TOWN OF CORTLANDT PLANNING BOARD

MEETING AGENDA.....PLANNING BOARD
TOWN OF CORTLANDT
6:30 THURSDAY EVENING*
JUNE 5, 2025

- PB 2024-6** **a.** Application of Richard Williams, P.E., on behalf of JAM Storage, LLC, for the property of Francisco Portillo, for Site Plan Approval and a Wetland Permit for the construction of an approximately 60,000 sq. ft. self-storage facility and related site improvements for property located at 2059 Albany Post Rd. Drawings dated May 27, 2025.

SCALE: AS SHOWN
DATE: 04/11/25
PROJECT NUMBER: 23014403A
DRAWN BY: ES
CHECKED BY: JWL
REVIEWED BY: JWL
SHEET NAME: CP 2

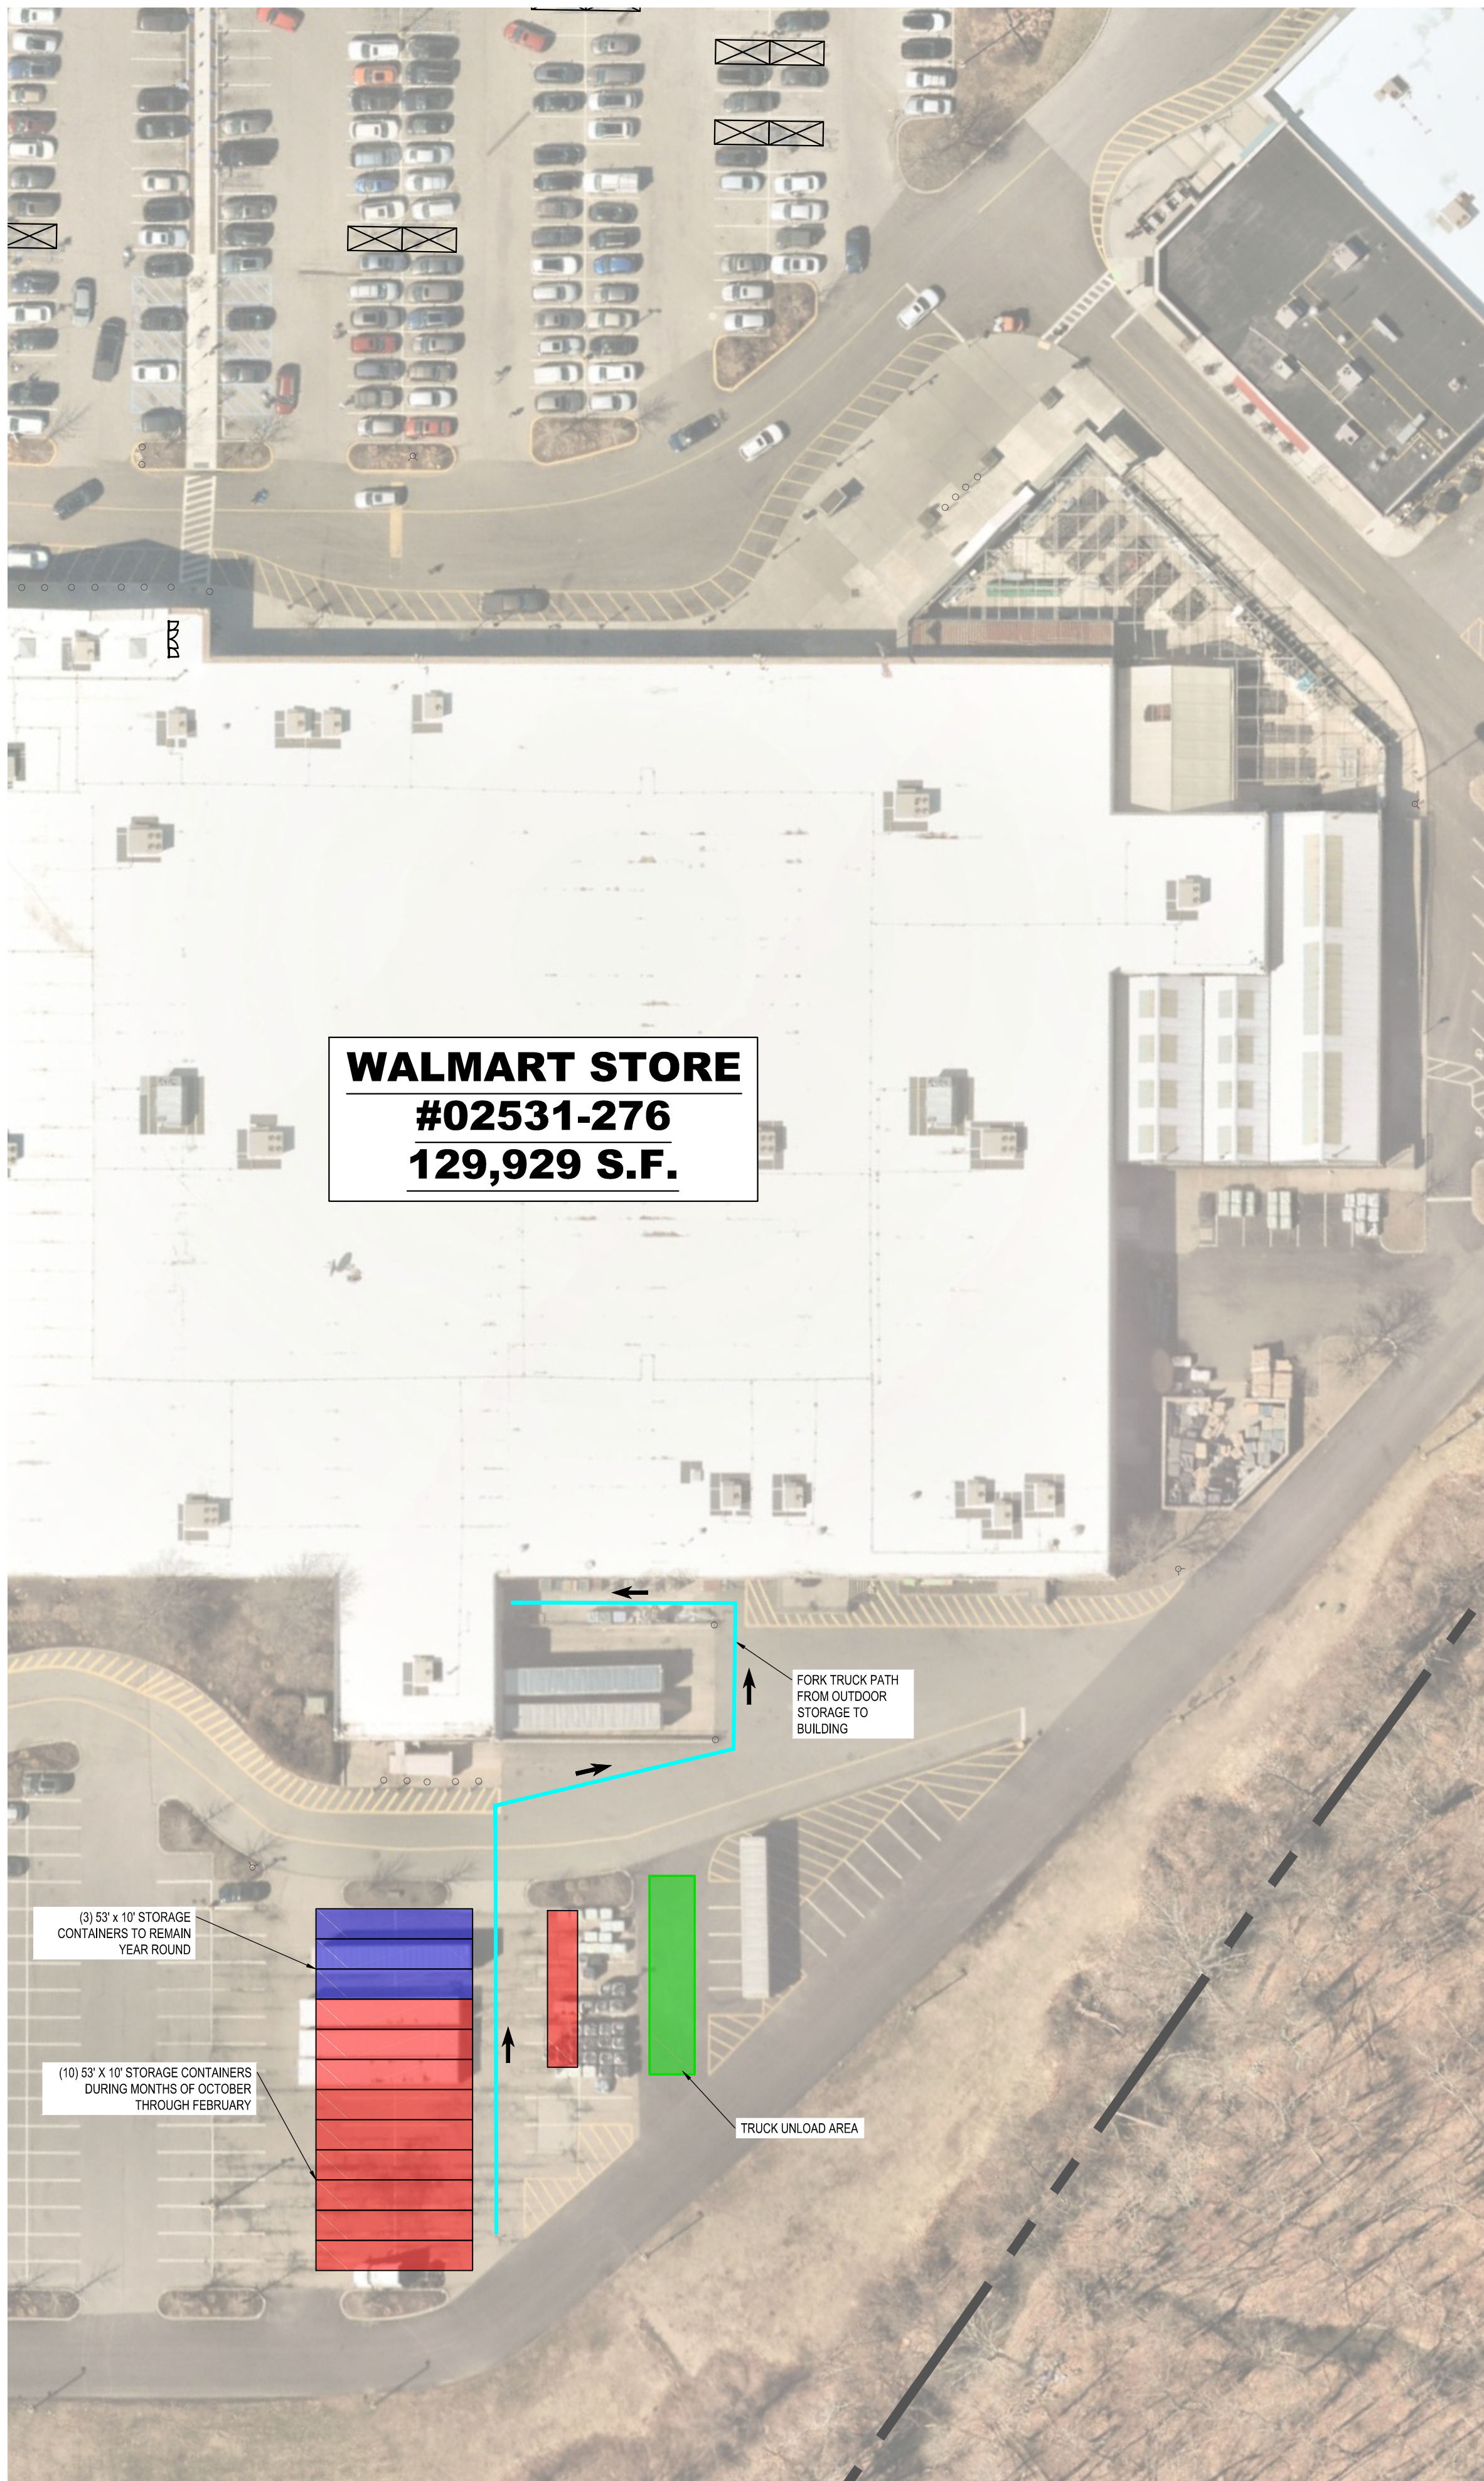
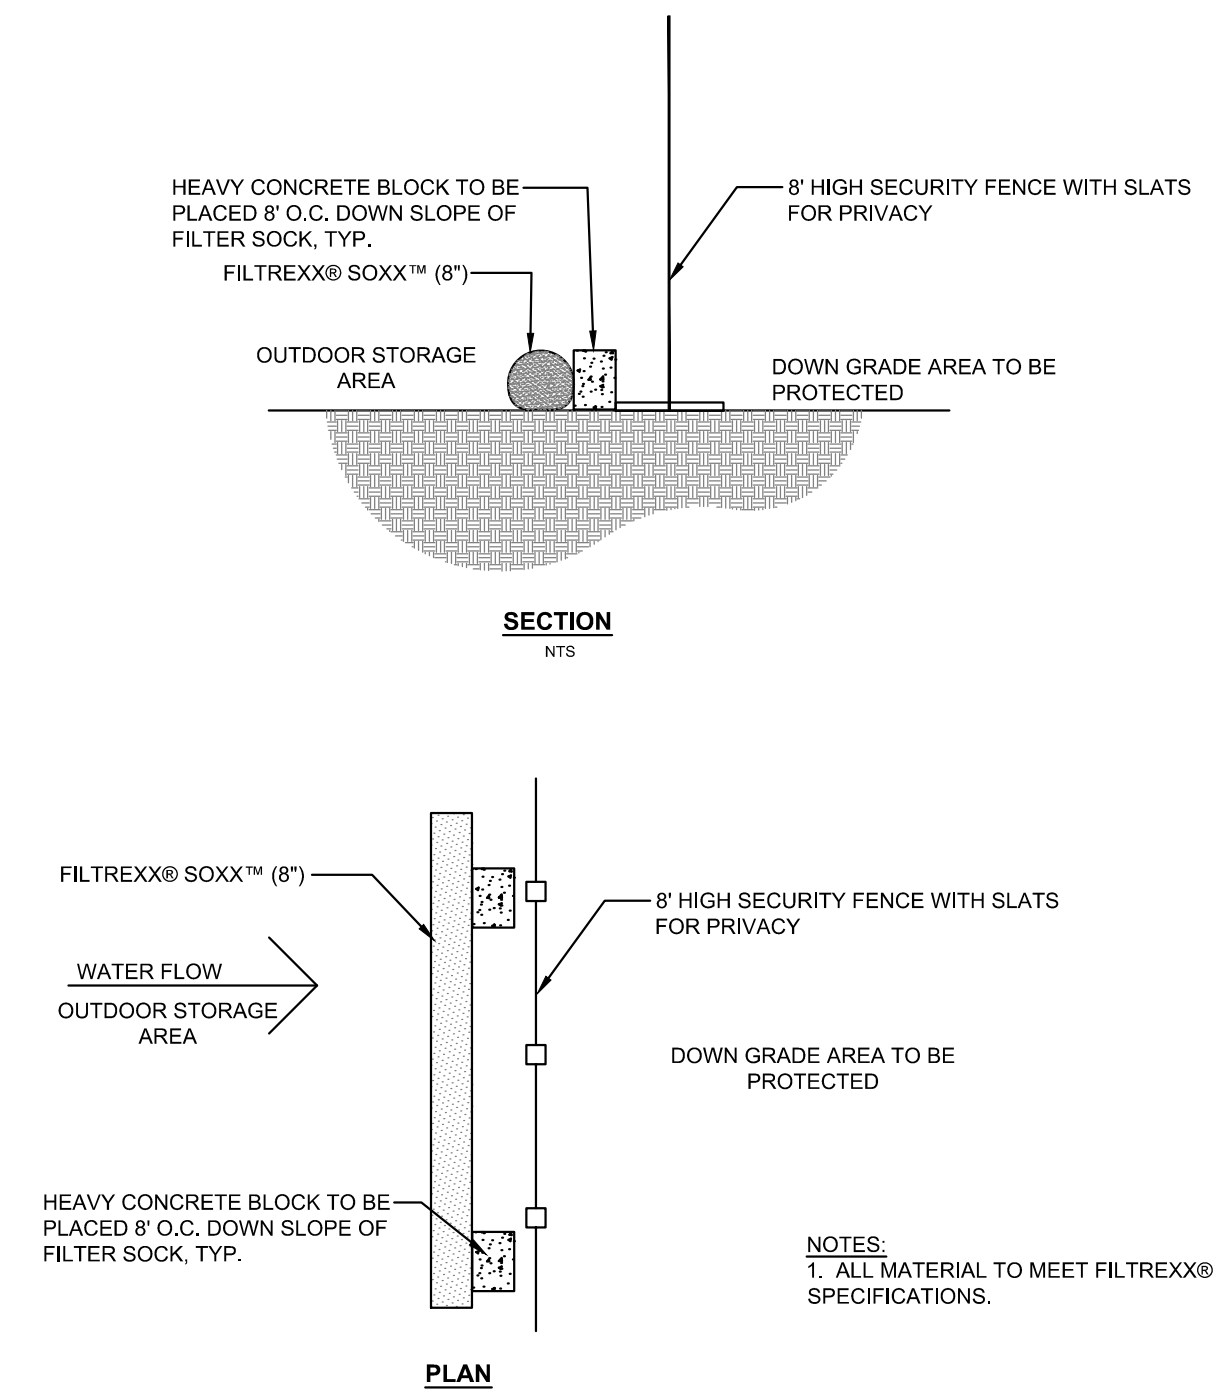
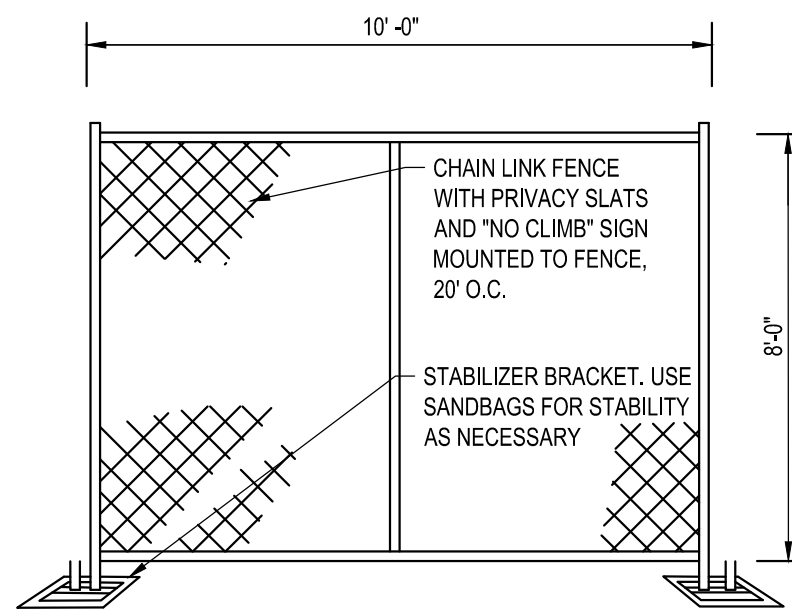
1. Fence shall be secured, slated for privacy and be "no climb". Fence height shall shown to a maximum of 8-ft. Detail accordingly.
2. Identify the type of goods and materials to be stored outside. .
3. Provide details for all proposed improvements including but not limited to erosion controls, fencing, shelving, etc...

4. Add the following notes to the plan:

- a. Walmart shall immediately notify the Town Center and Town of Cortlandt if any change to proposed storage of outdoor goods and trailers are proposed. No changes shall be made until approved by the Town of Cortlandt.
- b. There shall be no storage of flammable or hazardous materials in the trailers or within the confines of the storage area.
- c. Quarterly all site controls shall be inspected, with report provided to the Town of Cortlandt. Erosion controls and silt / filter socks shall be reset and all debris swept and removed from the storage area. All debris shall be lawfully disposed of offsite.
- d. Under no circumstance shall the main driveway aisles or fire lanes be blocked or obstructed, even for temporary delivery and offloading of goods and materials.

Please see attached revised plan for the Walmart exterior storage proposal. We will adjust if necessary and officially submit our plan and comment response letter in order to attend the 6/5 Planning Board meeting with a draft resolution.

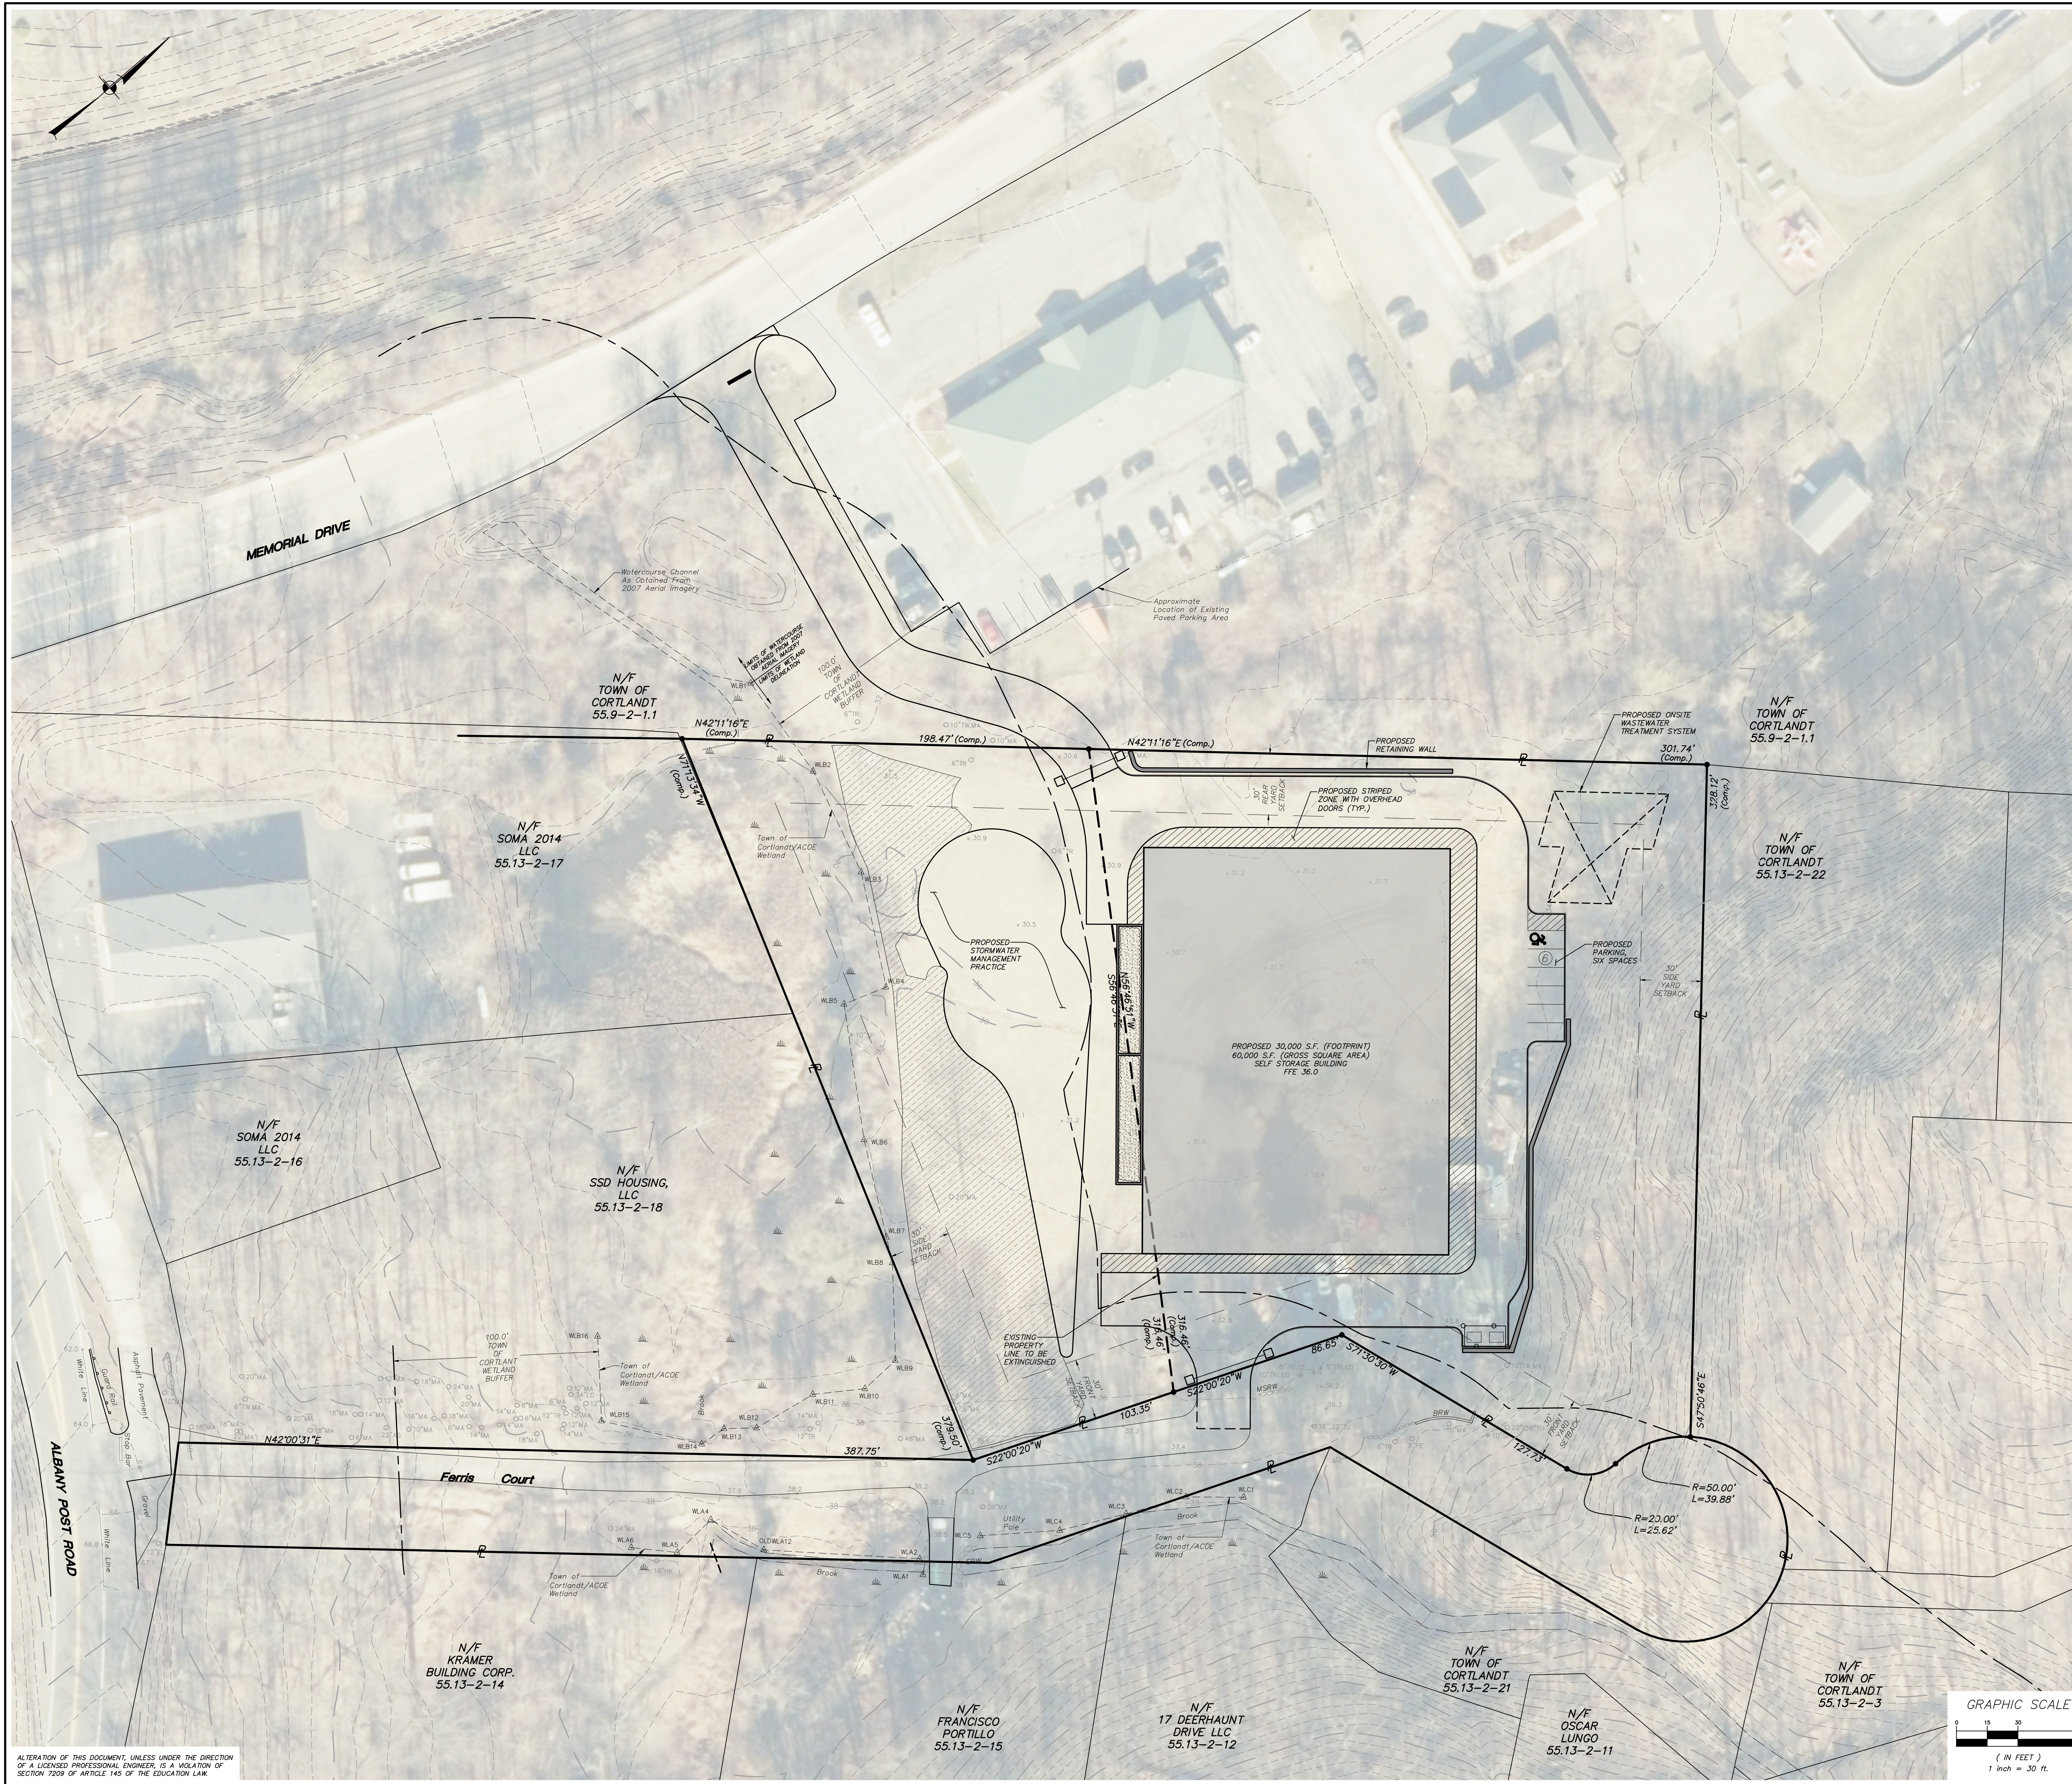
The wetland and wetland buffer disturbance charts at the bottom of sheet OP-1 shall be clarified and simplified to simply show the total amount of regulated wetland and wetland buffer site wide (right-of-way and within the lots), the total amount of wetland disturbance and wetland buffer disturbance site wide, and the total amount of proposed mitigation and ratio of mitigation.

9. *The striping adjacent to the accessible parking space must be 8 feet wide per the building code; it appears to be too narrow as shown on sheet OP-1.*

1. *Sheet OP-1 - Provide the number of stories for the proposed building, as well as overall square footage.*

2. *Sheet OP-1 - Will the reconstruction of Ferris Court impact other users? If so, how will this be mitigated.*

3. *Sheet OP-1 - The Applicant will need to upgrade the roadway (Ferris Court and building access drive) to meet the requirements of a fire apparatus access road which entails a pavement width of 26-ft. This will impact all site plan sheets and SWPPP calculations.*

The applicant has worked with the Town Board to secure a proposed access through the adjacent Town property. The wetland buffer disturbance charts on Drawing OP-1 have been updated to account for the new access through the Town property. Please note the offsite wetland on Town property was approximated using GIS mapping. The project's
